Kenya Power

RE: ADDENDUM NO.1 TO THE TENDER NO. KP1/9A/9AA.1A/OT/31/16-17 FOR PURCHASE OF TOOLS & EQUIPMENT FOR CUSTOMER SERVICE.

KP1/9A/9AA.1A/OT/31/16-17 PURCHASE OF TOOLS & EQUIPMENT FOR CUSTOMER SERVICE.

APPENDIX B:_METER RACK AND ACCESSORIES

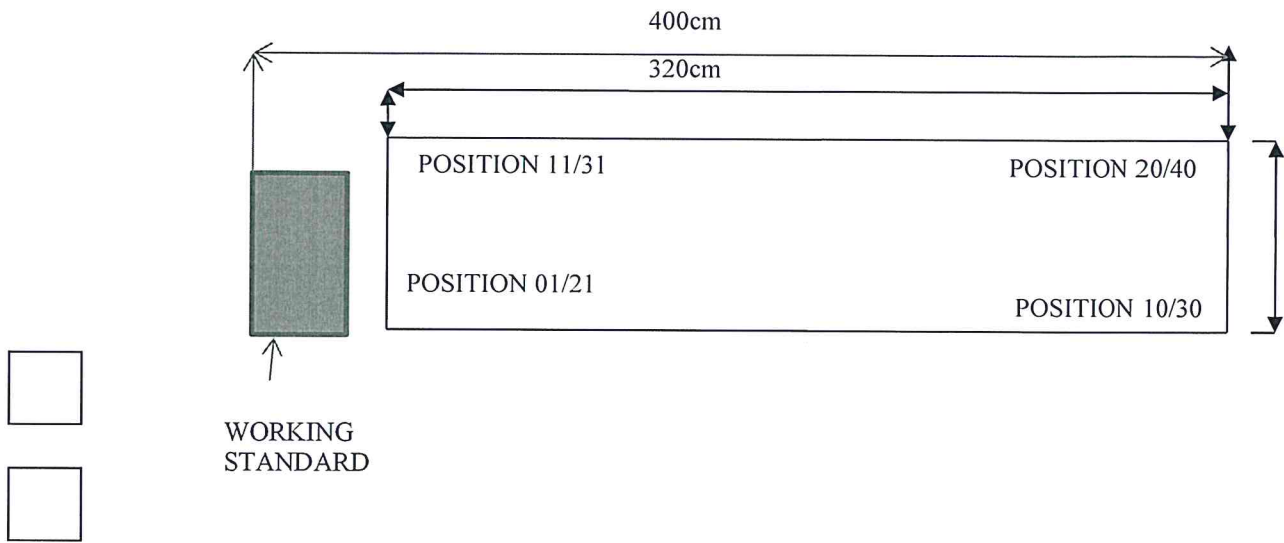
Item No.	Item	Description	KPLC Response
1	Single phase meter test bench	specs, point 4.2.14, “The <i>test bench shall have 40 position, 20 on each side</i> ”. On the other hand, at Appendix B the drawing, it shows 10 positions. Also, given max dimensions, 400(W) x 205(H) feels like 20 pos bench. Clarify whether to adopt the stated specifications in 4.2.14 or the drawings requirements	Refer to clause – 4.2.14 – The test bench shall have 40 positions, 20 on each side Also Amended Appendix B

The bench is 40 position.
It shall have 2 sides each consisting of two rows of testing positions.
Each side with 20 positions numbered as above
